**From:** Davenport, Greg <[gdavenport@hvac.me.com](mailto:gdavenport@hvac.me.com)>  
**Sent:** Friday, June 10, 2022 3:26 PM  
**To:** Kjell Anderson <[kanderson@lmnarchitects.com](mailto:kanderson@lmnarchitects.com)>; Braaksma, Krista (DES) <[krista.braaksma@des.wa.gov](mailto:krista.braaksma@des.wa.gov)>  
**Subject:** TAG follow up thoughts

## Cold Climate Performance

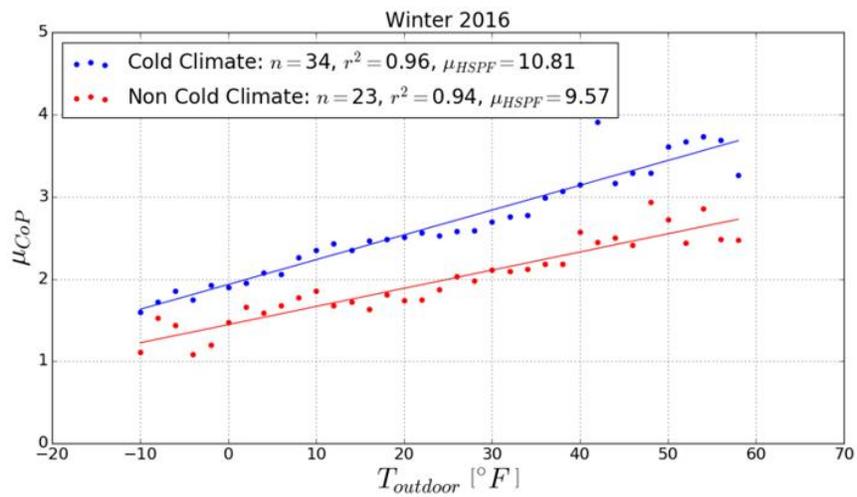
Since 024 has the relaxation (10 HSPF cc ASHPs vs 11 HSPF standard heat pumps) to encourage cc ASHPs, some of the intent got lost in the rewording. The intention is to allow builders to claim this credit when they use a NEEP qualified cc ASHP of 10HSPF or greater whether or not the design temp is  $\leq 23F$ . Most standard heat pumps really lose output below 35F. We can encourage better HVAC design and energy efficiency on this one if we allow builders to use cc ASHPs @ 10 HSPF regardless of design temp. The attached graph from a Cadmus study illustrates design temps and performance of standard vs cc ASHPs very nicely and shows that homes in the 23F-35F will benefit significantly from being included in the exception.

Kjell, can we revisit this in an upcoming meeting and see if we can fix this bit? I am ok if we put the graph up on screen and I can explain it. My feeling is that this will not be a contentious fix with the group.

I took a stab at wording 024 to capture the original intent. See attached.
